HUNTS POINT INTERSTATE ACCESS IMPROVEMENT PROJECT – CONTRACT 3

PIN X731.65, Contract D900055

Addendum #8

July 22, 2022

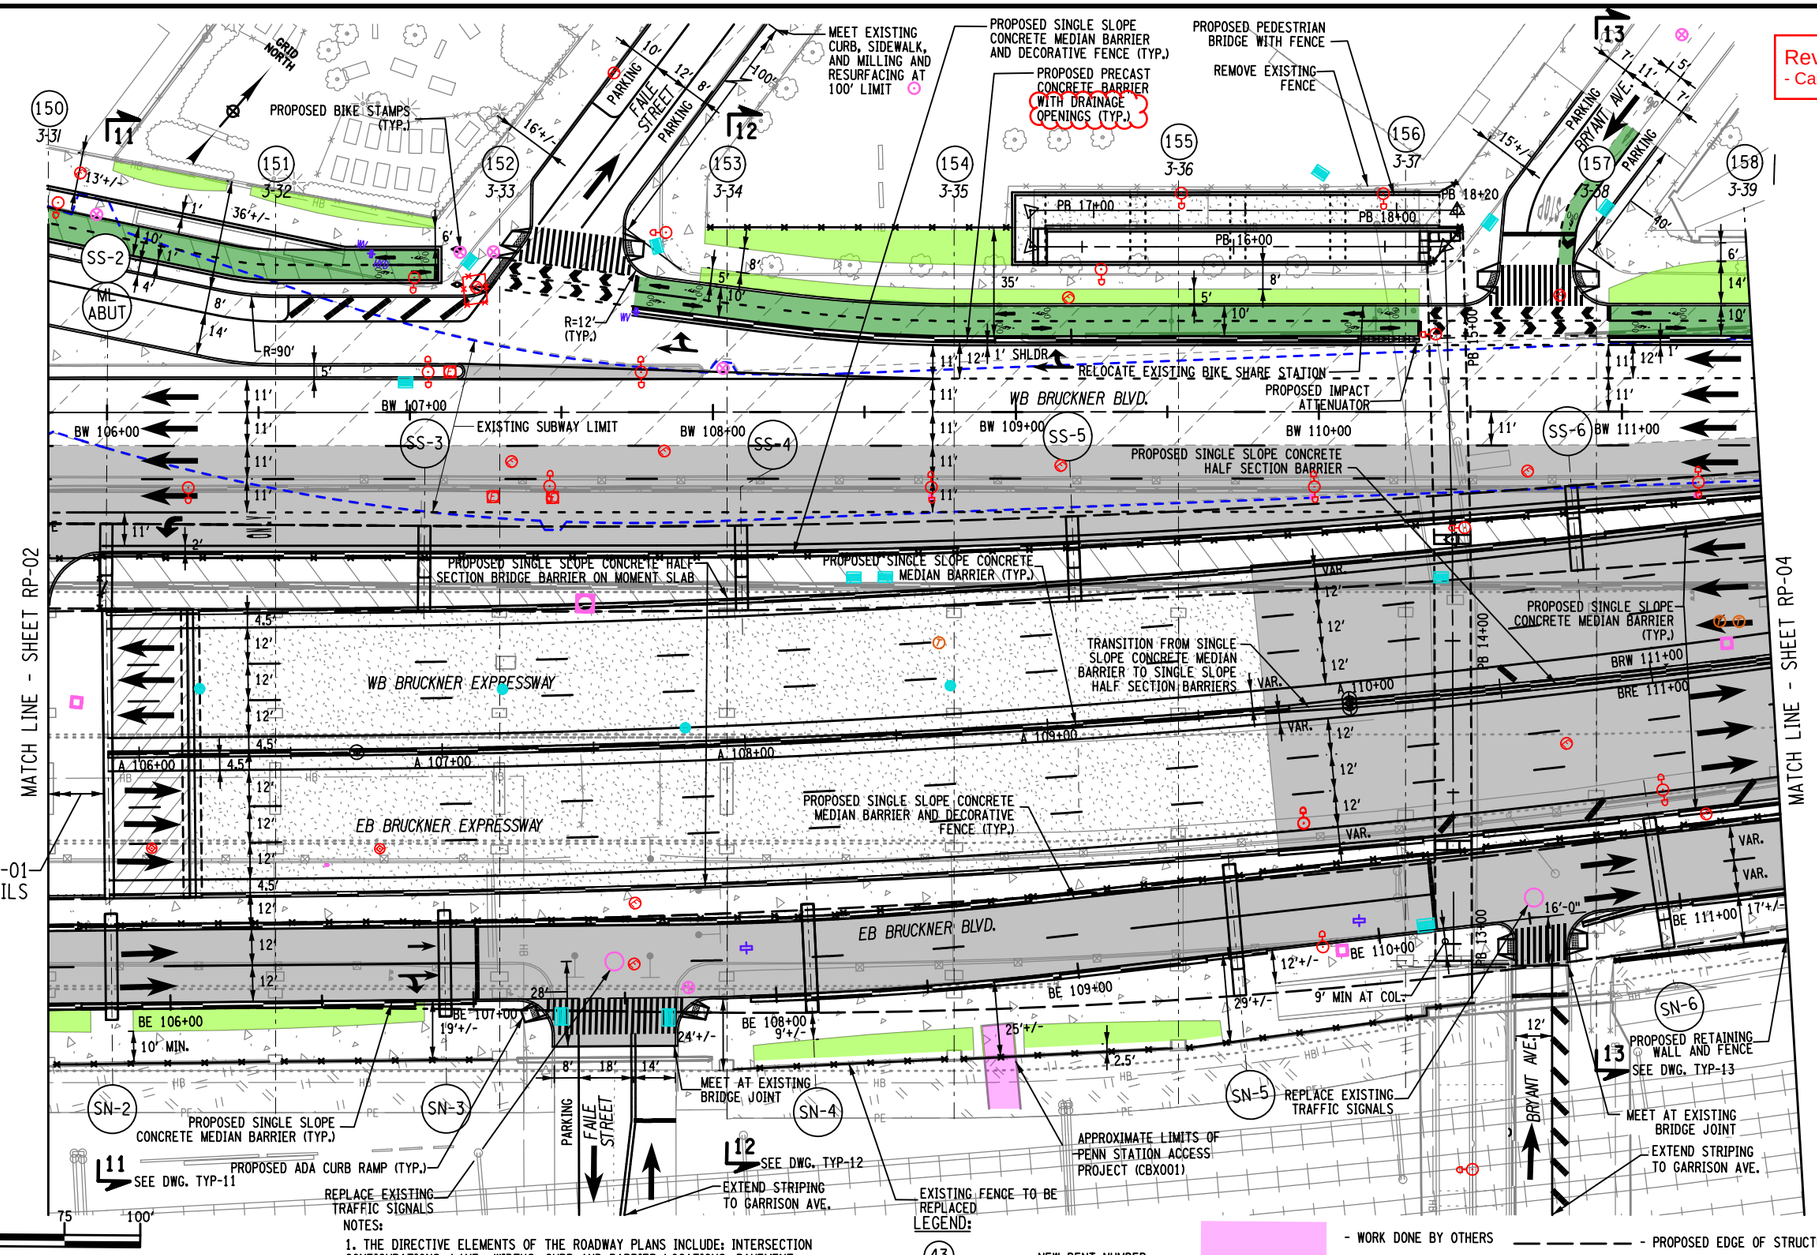
Revisions Made:
- Callout revised

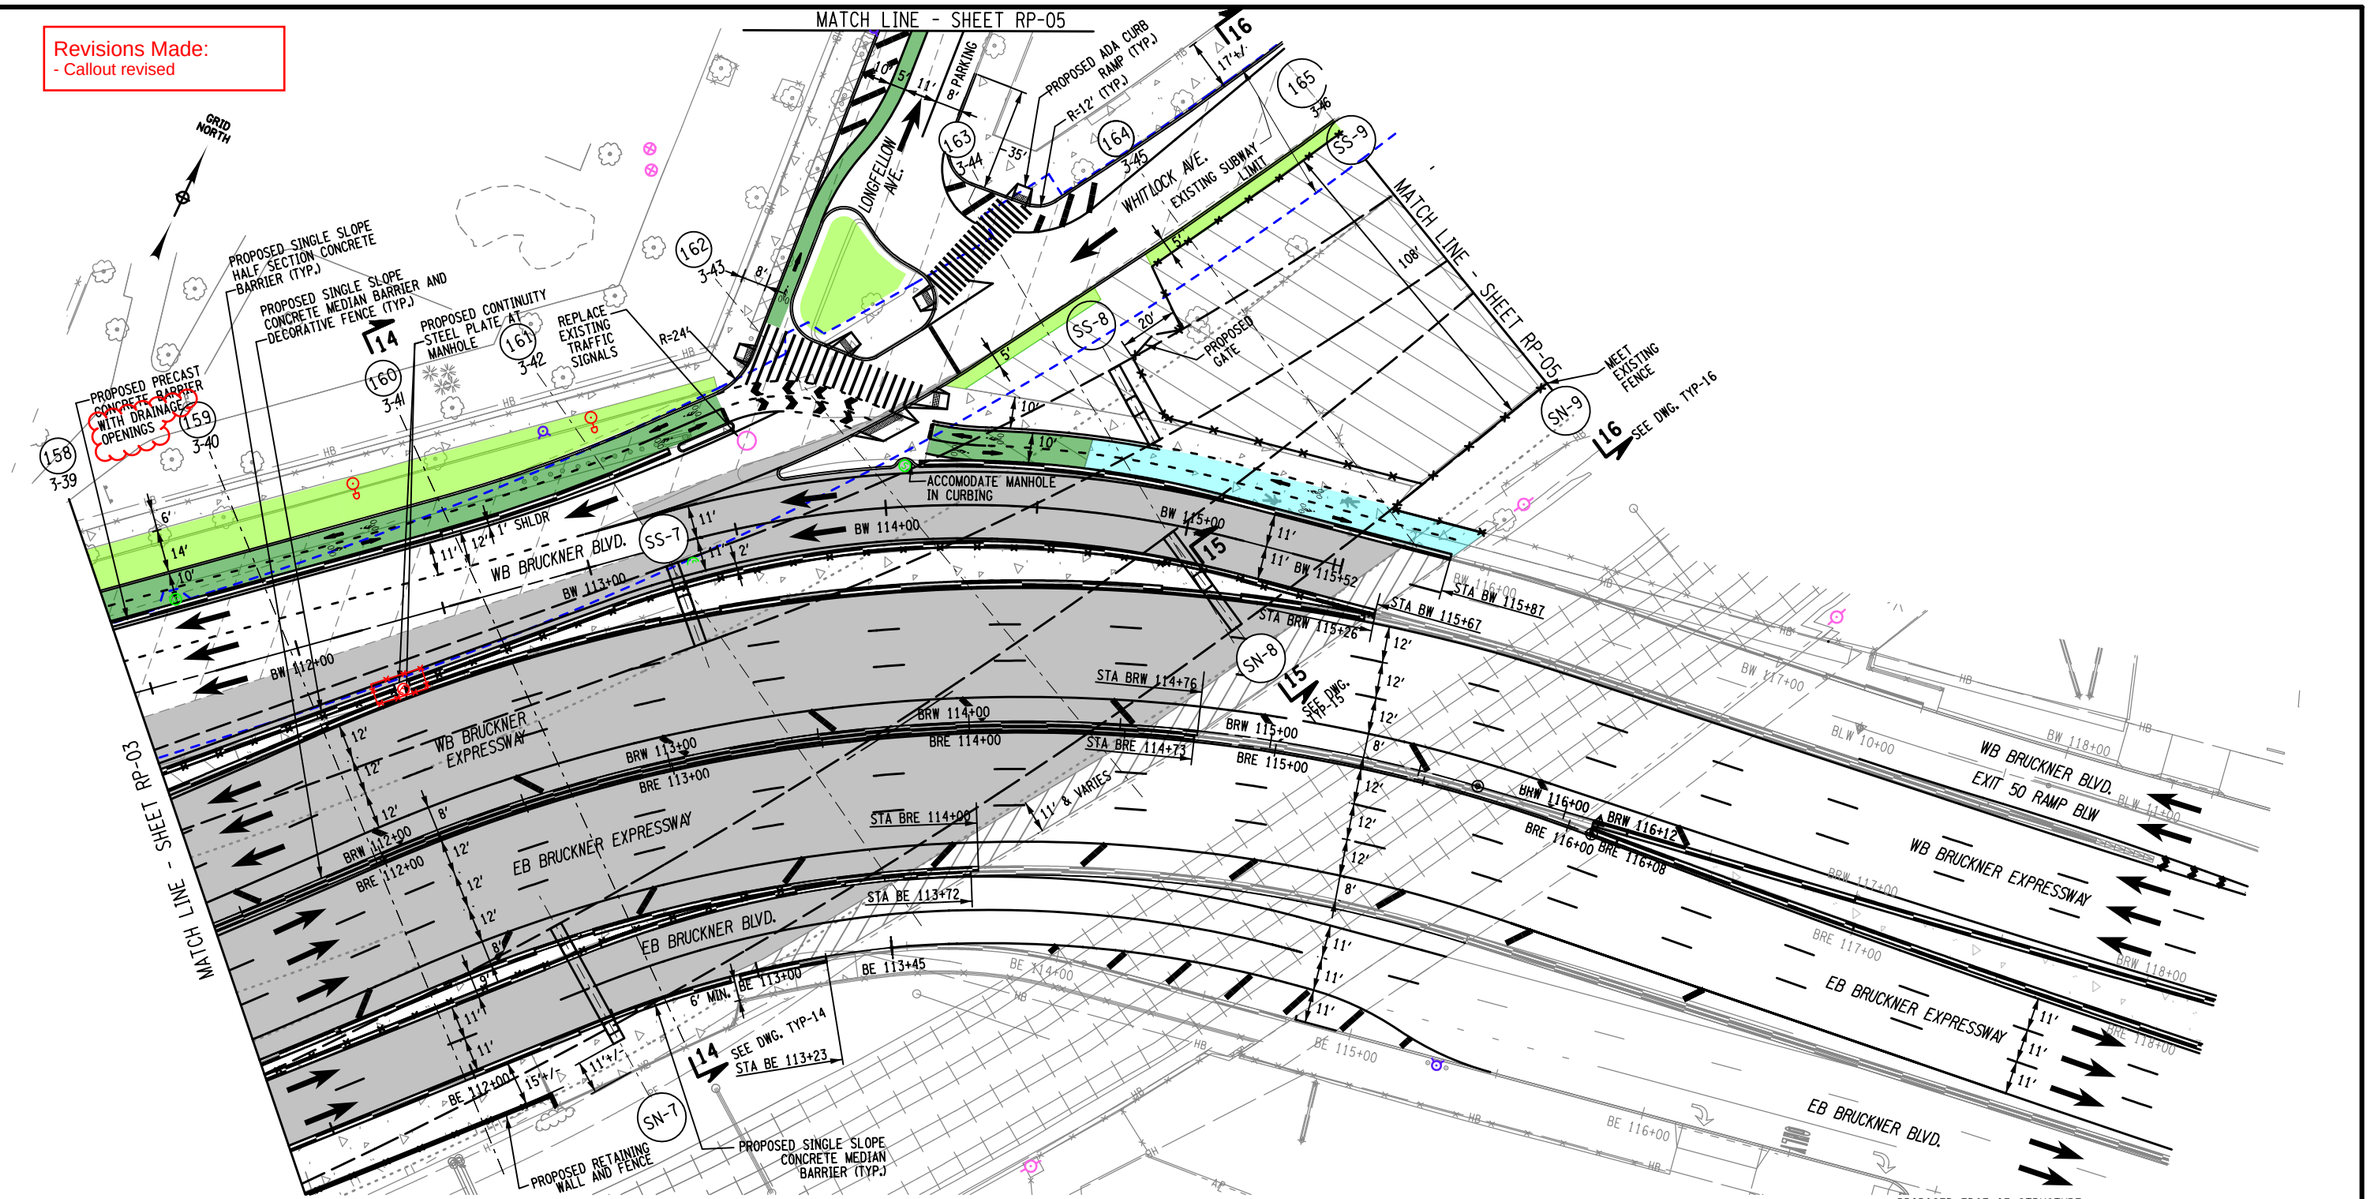
Revisions Made:
- Callout revised

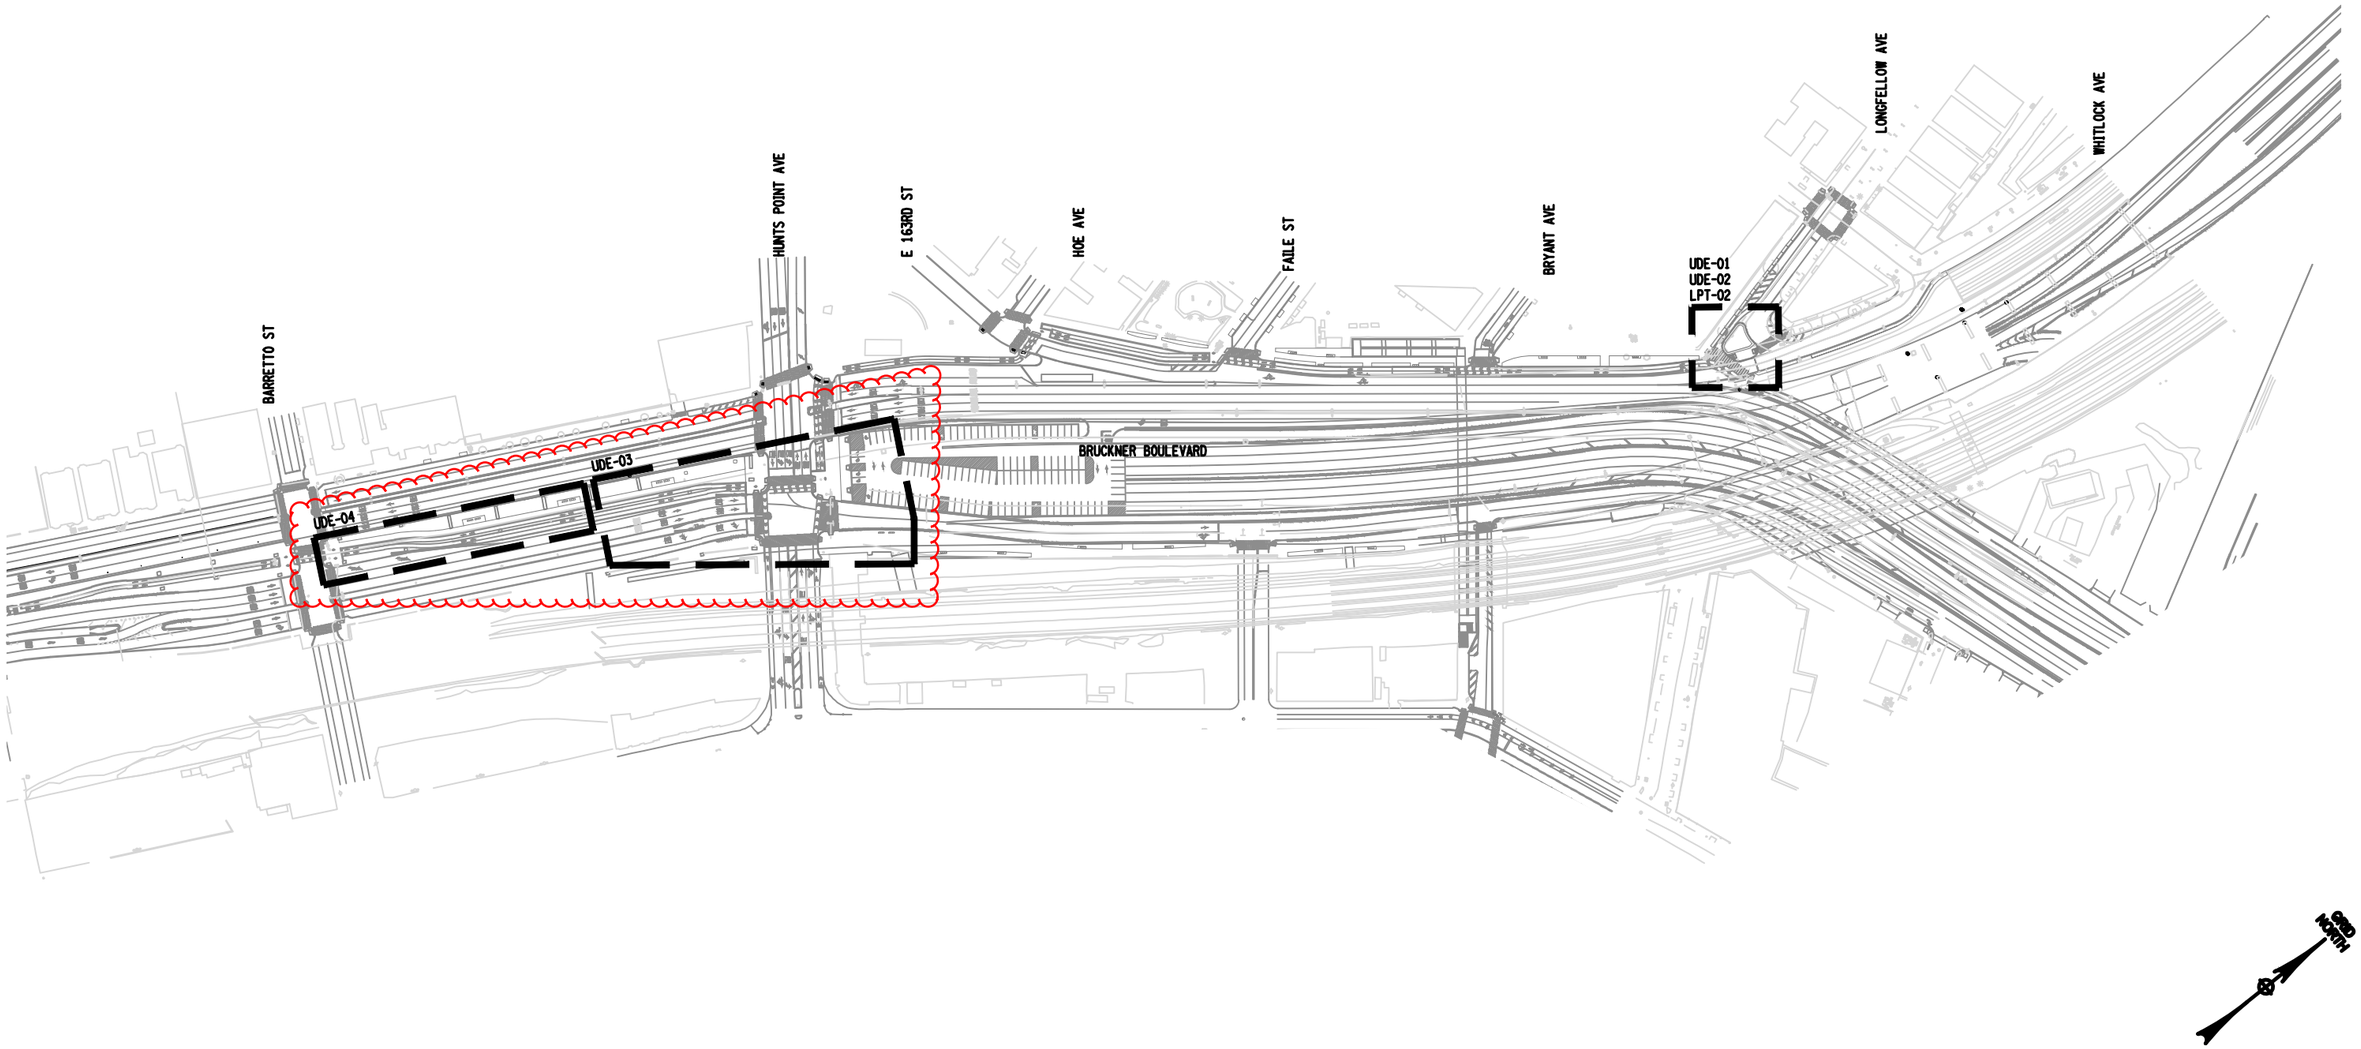
- Enlargement callouts added to Key Plan.

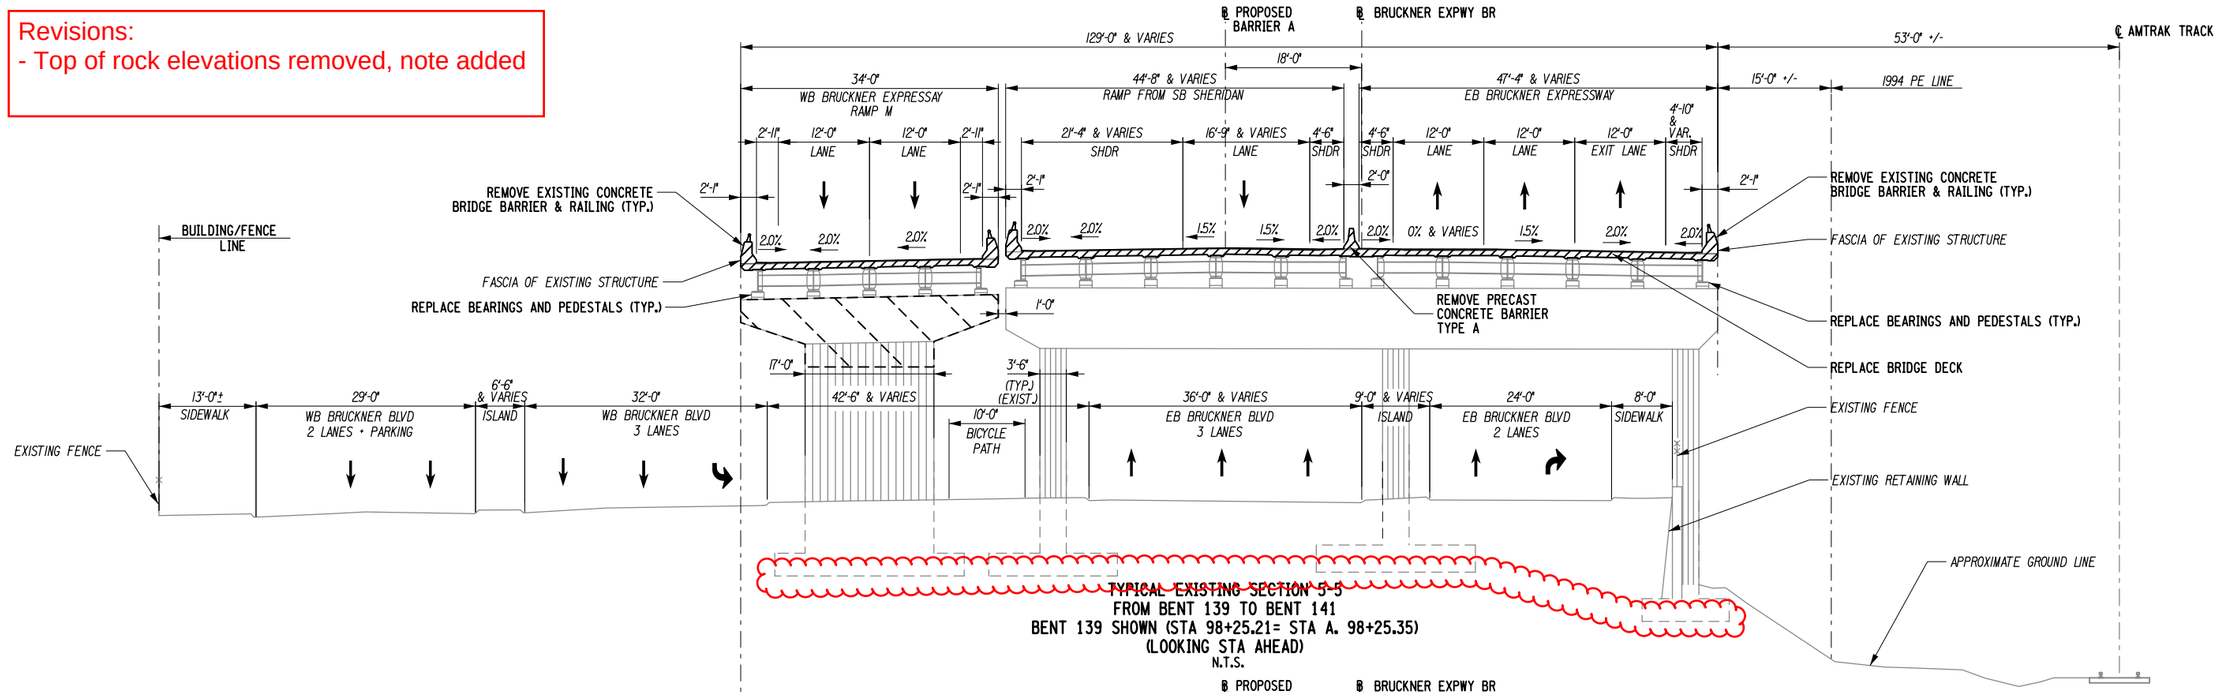
Revisions:
- Top of rock elevations removed, note added

NOTES:
1. FOR TOP OF ROCK ELEVATIONS, SEE GEOTECHNICAL DATA REPORT.
